HENDERSON COUNTY BOARD OF COMMISSIONERS

SUBJECT: Mills River Sewer Interceptor Project:
Request to file condemnation actions

ATTACHMENTS: Drawing of Proposed Re-alignment

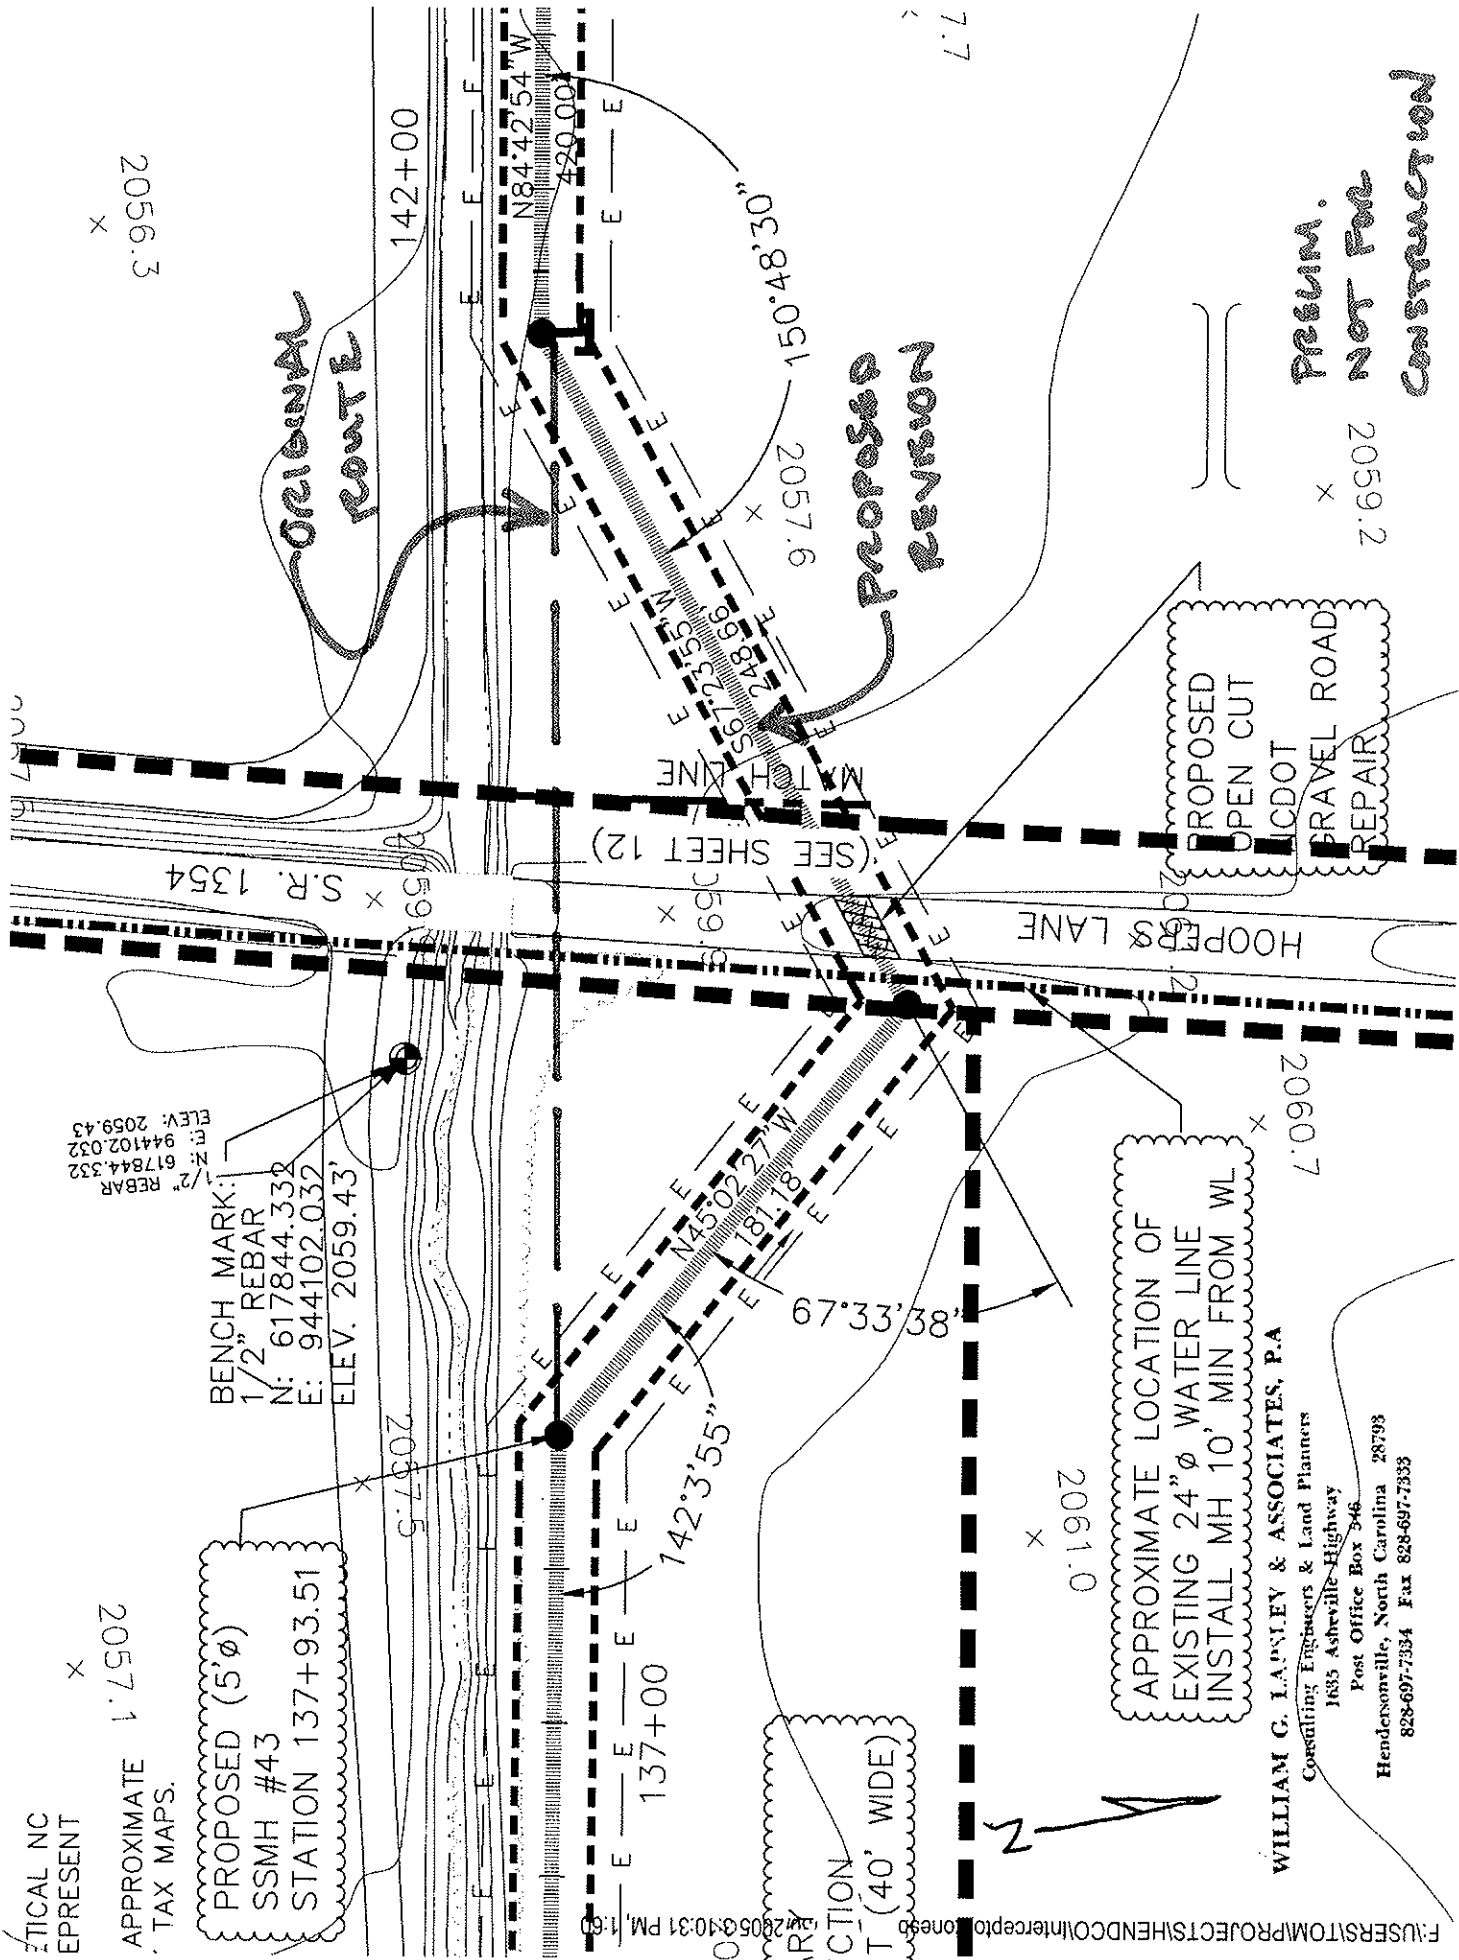
Due to a conflict with an existing twenty-four inch (24") diameter water line, it has become necessary to make a change (as shown on the attached drawing) in the route of the subject Sewer Interceptor.

APPROXIMATE LOCATION OF
EXISTING 24"Ø WATER LINE
INSTALL MH 10' MIN FROM WL

ORIGINAL
ROUTE

PROPOSED
REVISION
